LEGG ARCHITECTURE, LLC

May 03, 2023

Lion & Rose British Tavern and Pub - 23110 W I-10, San Antonio, TX 78257

ADDENDUM 1

SHEET NO.
A2.6

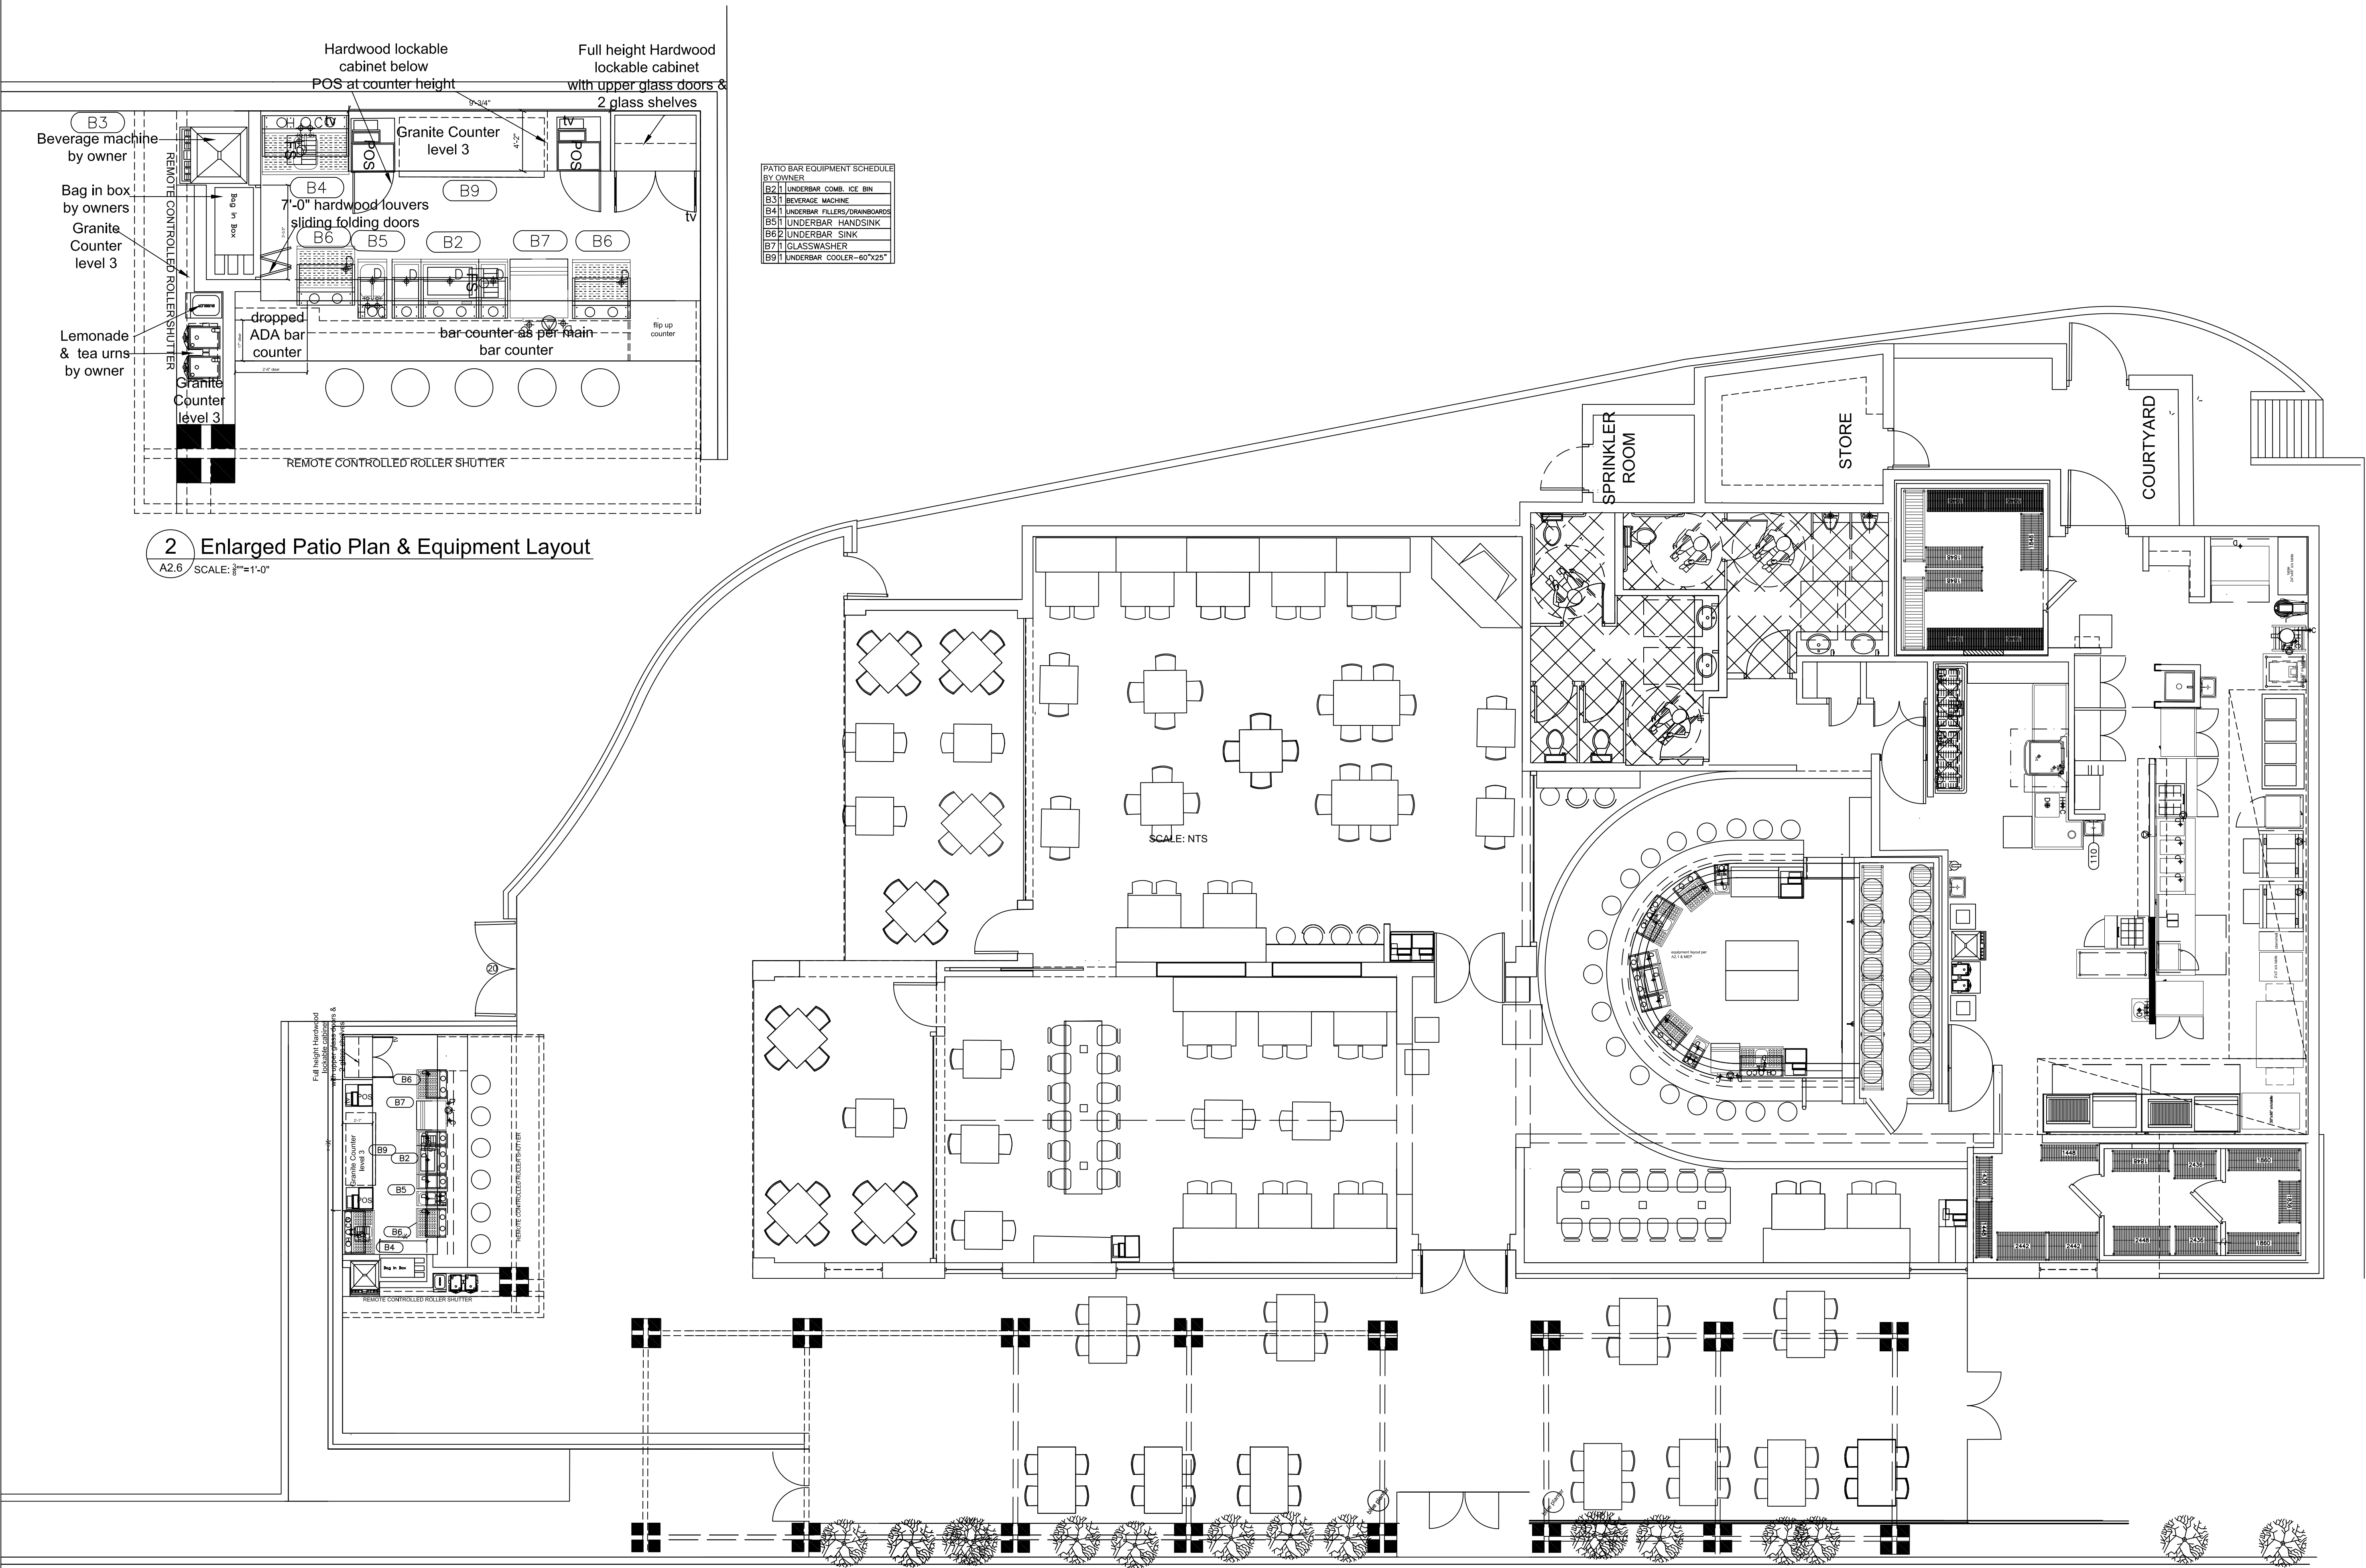
- 3.5 Sheet A2.1; A2.7; A6.6; A6.7 Granite slabs (level 3) required for main bar island and beverage counter at patio bar
- 3.6 Sheet A6.7; A2.1; A2.6 Allow for dropped ADA to main bar; patio bar and 12 seater tables
- 3.7 Sheet A2.6; A6.7 Patio Bar – COSA amendment/Ceiling finish: Trusscore Wall & Ceiling Board - White 16" x 20'2x12 beams to be 18" cc's and not 24". Beams to be finished with sealed with polyurethane finish. Walls to be finished with washable paint. Add beverage machine and bag in box with stained 7' wooden louver sliding folding doors. New hardwood display cabinet with lights added
- 3.8 Sheet A7.0 Rev 01 – 12 Seater tables to be solid smooth stained hardwood
- 3.9 GC to assist owner TV vendor with installation of TV's and mounts provided by owner.
- 3.10 Fire Sprinkler – allow for pipes to be painted
- 3.11 Stucco – expansion joints as per minimum industry standards

SHEET NO.
A6.6

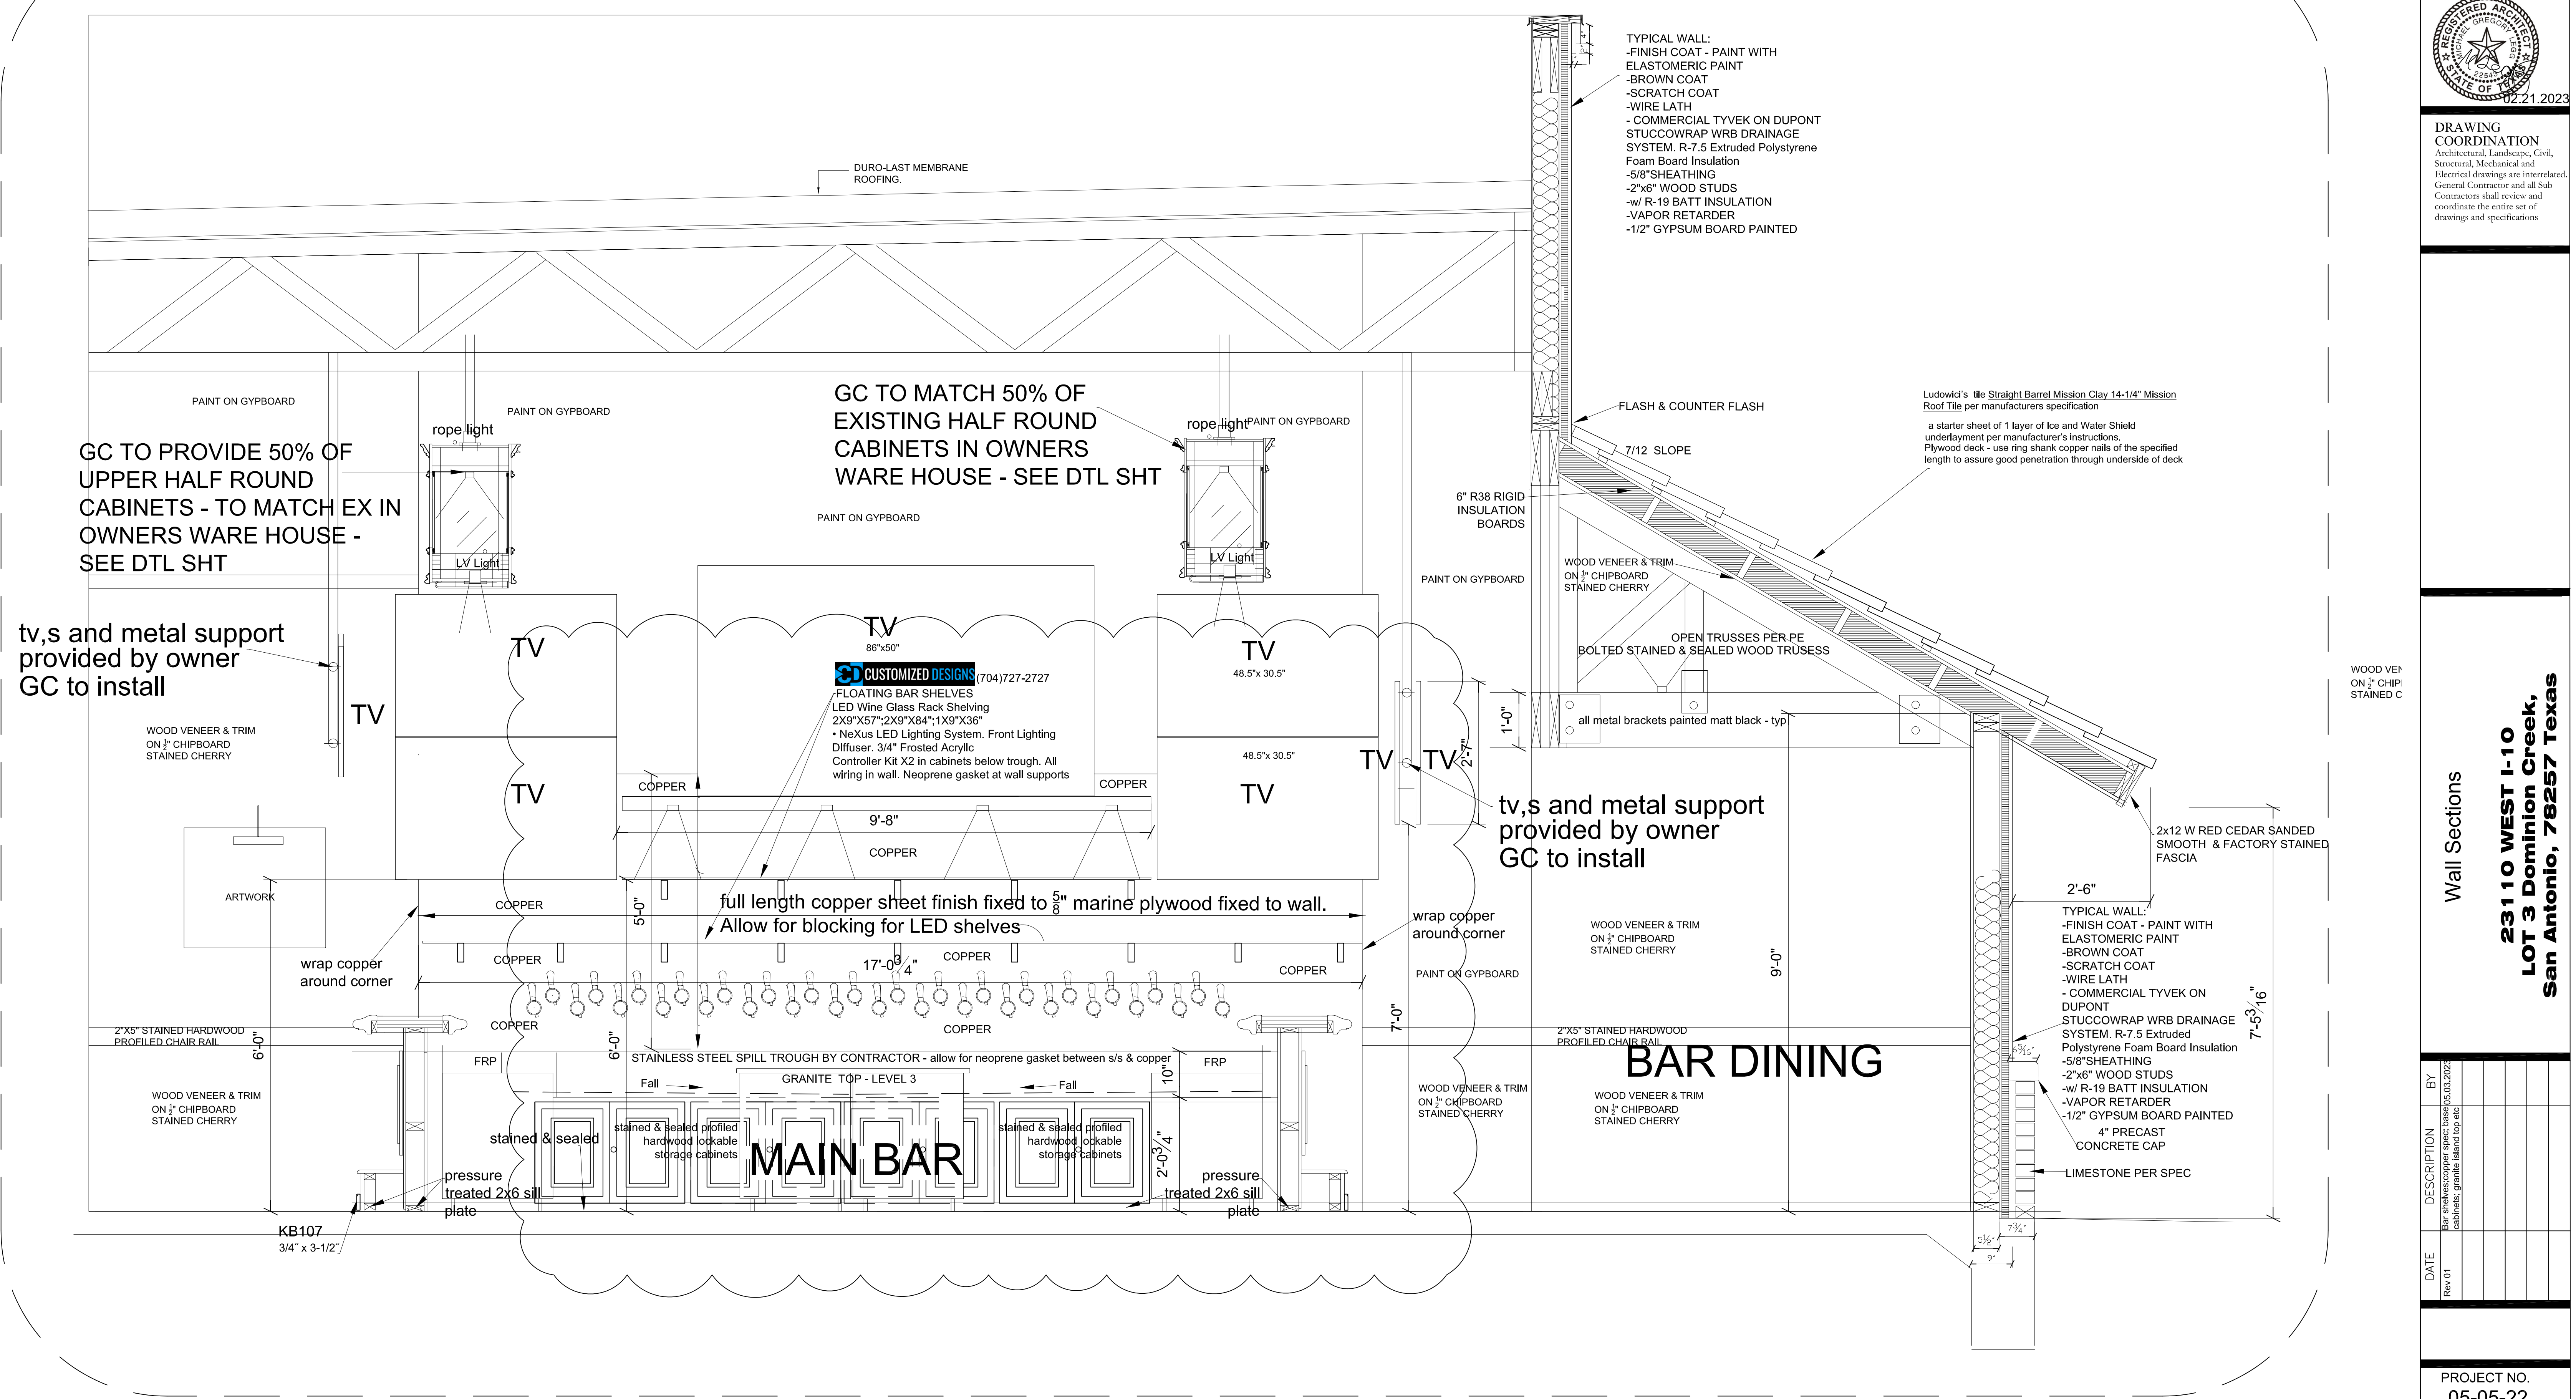
- 3.2 Sheet A2.1 Kitchen Equipment – Items 801; 802 & 803 are by main contractor.
- 3.3 Sheet A6.6 Copper sheet finish specification – 16mil 26 ga for main bar wall finish and 10mil 30 ga copper gutter details for clay roof tiles. Main Bar – 36" minimum width roll horizontal with minimum 84" horizontal copper seam and vertical copper trim at corner returns
(info@basiccopper.com phone at 252-491-2812)

- 3.4 Sheet A6.6 Omit glass shelves to main bar and add FLOATING BAR SHELVES BY CUSTOMIZED SHELVES (704)727-2727; LED Wine Glass Rack Shelving 2X9"X57"; 2X9"X84"; 1X9"X36"; • NeXus LED Lighting System. Front Lighting Diffuser. 3/4" Frosted Acrylic
Controller Kit X2 in cabinets below trough. All wiring in wall. Neoprene gasket at wall supports
